URGENT FIELD SAFETY NOTICE

GE HealthCare Ref. # 32089

RE: **Giraffe OmniBed and Giraffe OmniBed Carestation potential incorrect secondary latch installed on certain bedside panels.**

Figure 2. North end bedside panel latch locations

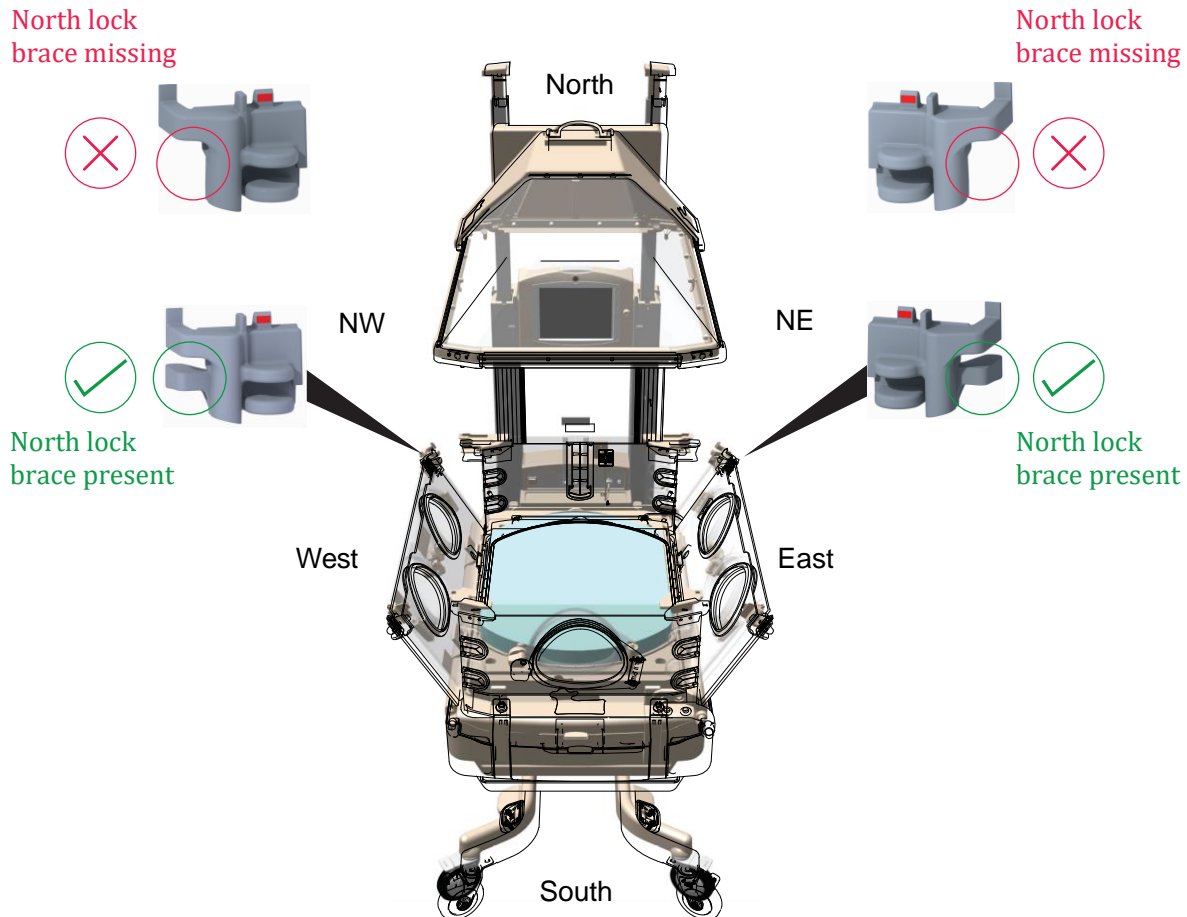
1. Visually inspect the NW and NE bedside panel latch assemblies on all Giraffe OmniBeds and Giraffe OmniBed Carestations to ensure the correct latches are present (See Figure 2).

2. If an incorrect latch is found quarantine the device.
3. Inspect any field replaceable bedside panel stock at your facility per Figure 2 for the parts #'s listed below to ensure the correct latches are present and quarantine any field replaceable bedside panels with incorrect latches.
 - 5865384-01 to 5865384-34,
 - 5865385-01 to 5865385-34,
 - 5865386-01 to 5865386-34 and
 - 5865387-01 to 5865387-34
4. Record the results of the inspections on the provided Medical Device Notification Acknowledgement Response Form and send this form to GE HealthCare at MIC.FMI32089@ge.com
5. GE HealthCare will contact you to arrange for shipment of replacement latches. These will be provided free of charge to you.

6. Once correct latches are received, replace the incorrect latches with the correct latches and dispose of the incorrect latches.
